DOWNTOWN URBAN DESIGN REVIEW BOARD

NOTICE OF PUBLIC MEETING

Project Information: COA-18-06, 4/4/2018 DDRB Hearing

Project Name: SW 8th Ave. & S Harrison St. – BCS, Office and Bus Garage
Project Address: 720 South Tyler Street & 800 South Harrison Street, Amarillo, TX
Zoning: Central Business District (CB)
Historic Designation: () National () State () Local (X) N/A
Construction: (X) New (X) Renovation/Remodel () Addition

Screenshot of Streetscape (SE Side)

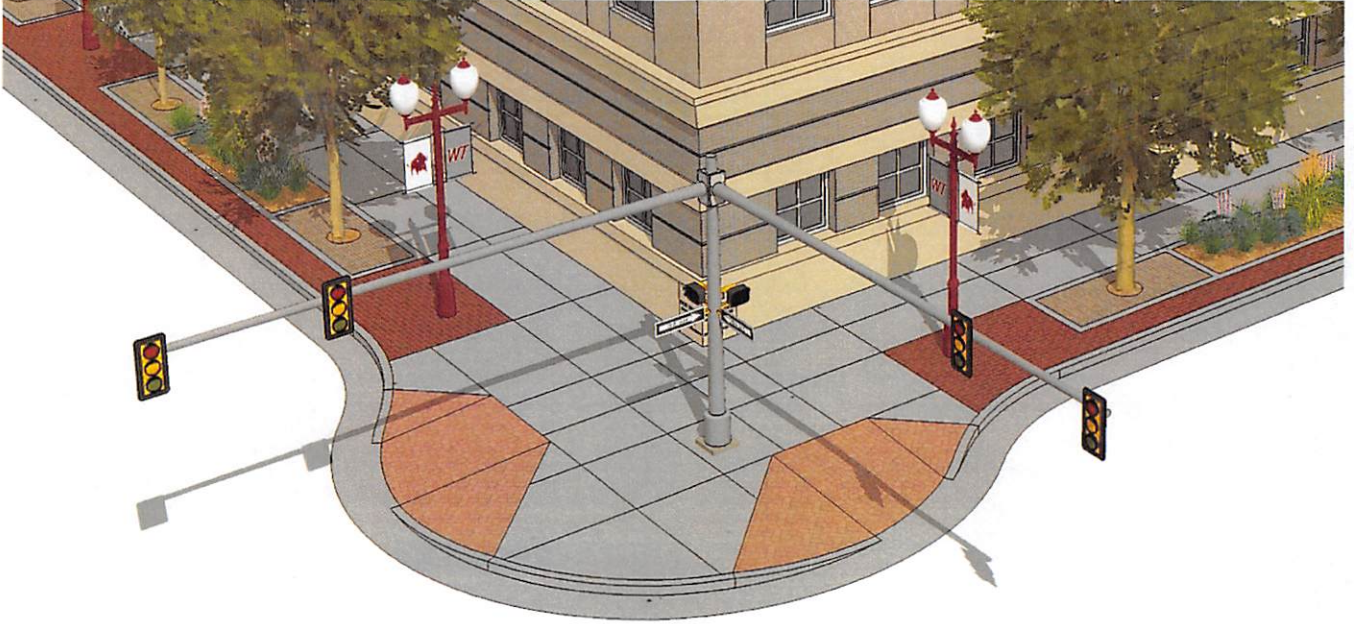
- The proposed site plans show city approved pedestrian lighting, and the spacing also is adequate being 50'. However, the colors of these light poles are to be black per standard (Shown on Page 11 and 13 of DAUDS booklet) and the site plan notes them painted as maroon (WTAMU's standard colors). As such, the applicant has requested a variance for all light poles on their frontages, which is summarized in the Variances section below.

Variance 1: A complete variance from street lighting color of black to allow the color maroon instead for WT's standard color.

Staff recommends approval of the item as presented along with variance 1.

Site Layout Plan

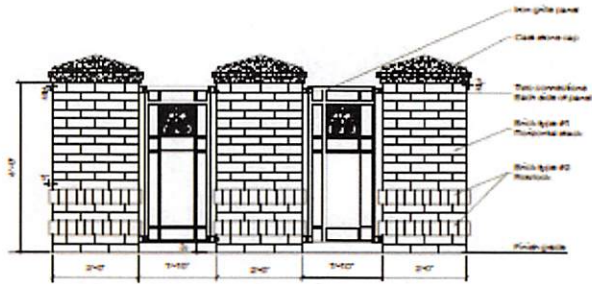
- A 7' (minimum) unobstructed pedestrian pathway is required.
 - The site plans submitted for this project indicates a proposed 7' unobstructed sidewalk on all of the properties. The proposal of a minimum 7' sidewalk for the DAUDS is correct, thus meeting the sidewalk standards.

Fencing Elevations

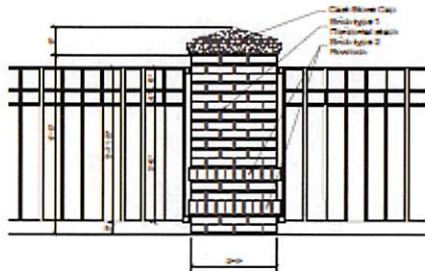
- Minimum Standard: Parking lots adjacent to the pedestrian walkway shall be visually screened with landscaping and/or fencing or walls of 3- 4' in height. Fencing and walls must be of high quality material, such as metal, wrought iron, brick or stone. Private, secured parking lots may be fenced with quality fencing materials and be no higher than 6' tall.
 - Proposal: There are two parking lots with one existing parking lot (Block 103) that will be improved which is adjacent to the pedestrian walkway along South Harrison Street for both lots; the (private) parking lots (Block 103 and WT Center) are screened on private property along all frontages with 4' fencing made of brick and wrought iron which meets the standards for private parking lot fence screenings.
